**SUBDIVISION &**

SIDEWALK WAIVER STAFF REPORT Date: July 11, 2013

**SUBDIVISION NAME** Mobile Terrace Christian Center Subdivision

**LOCATION** 7154 Ninth Street

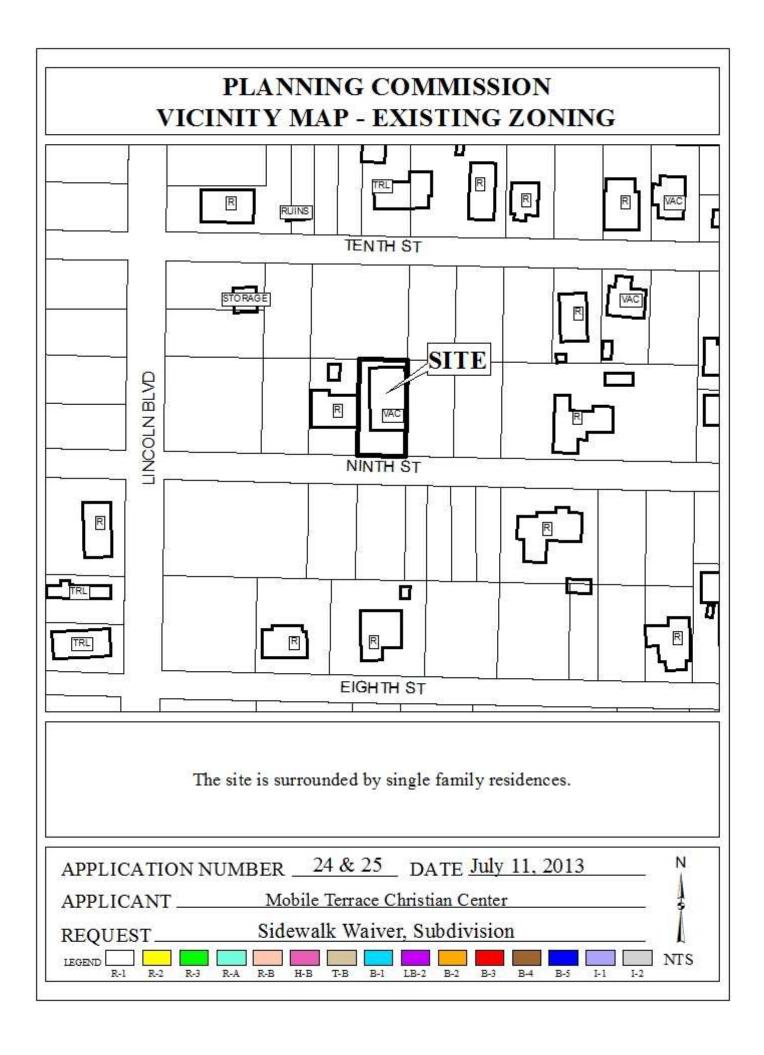
Finally, the preliminary plat submitted for review does not appear to be "to scale," as required by the Subdivision Regulations (the plat is labeled as 1 inch = 20 feet, however it does not measure to that scale). The applicant should ensure that the final plat is plotted to a standard engineering scale.

- 1) Revision of the plat to ensure that it is plotted to a standard engineering scale;
- 2) Revision of the plat to depict the minimum setback line to allow for future dedication to provide 25-feet from the centerline of Ninth Street;

- 3) Placement of a note on the final plat stating that the lot is limited to two curb-cuts, with the size, design and location to be approved by Traffic Engineering and to conform to AASHTO standards;
